UNITED STATES PATENT AND TRADEMARK OFFICE

APPLICATION NO.	FILING DATE	FIRST NAMED INVENTOR	ATTORNEY DOCKET NO.	CONFIRMATION NO.
10/055,757	01/22/2002	Rich Baranski	57111-5103	7325

Office Action Summary

DETAILED ACTION

Figure 1'

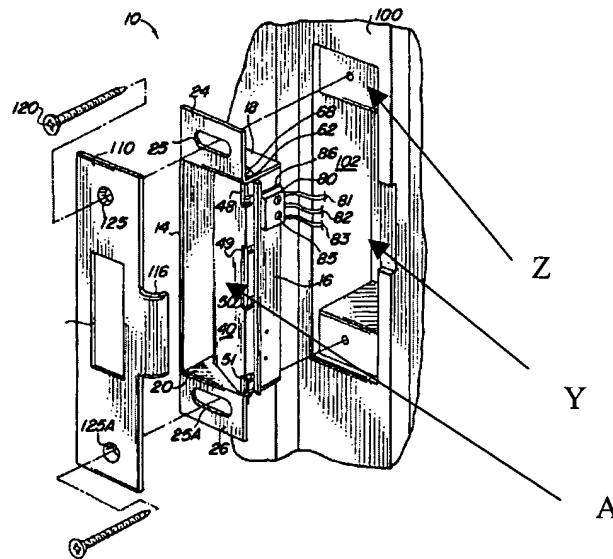
4. Claims 19-20 are rejected under 35 U.S.C. 102(b) as being anticipated by Roth (U.S. Patent No. 5,757,269). Roth discloses an adjustable door guide latch slot assembly as claimed; wherein said assembly includes a striker plate (110) having a latch opening (112) therein; a door guide having an outer surface (Z) and an inner surface (Y) with a recessed area larger than said striker plate and having an opening therein extending from the inner surface to the outer surface with said opening being larger than said striker plate latch opening; and a security device (12) having a latch receiving port (A), the security device extending out from the outer surface of the door guide, whereby said striker plate maybe placed flat against said door guide inner surface within said recessed area and maybe adjustably affixed to said door guide inner surface so that said striker plate latch opening aligns with said slidable door latch and whereby said security device is affixed to said adjustable striker plate so that said latch receiving port aligns with both said striker plate latch opening and said slidable door latch. As it concerns claim 20, as shown in

Figs. 3A & 3B, the depth of said recessed area is at least as great as the thickness of said striker plate, see Fig. 1'.
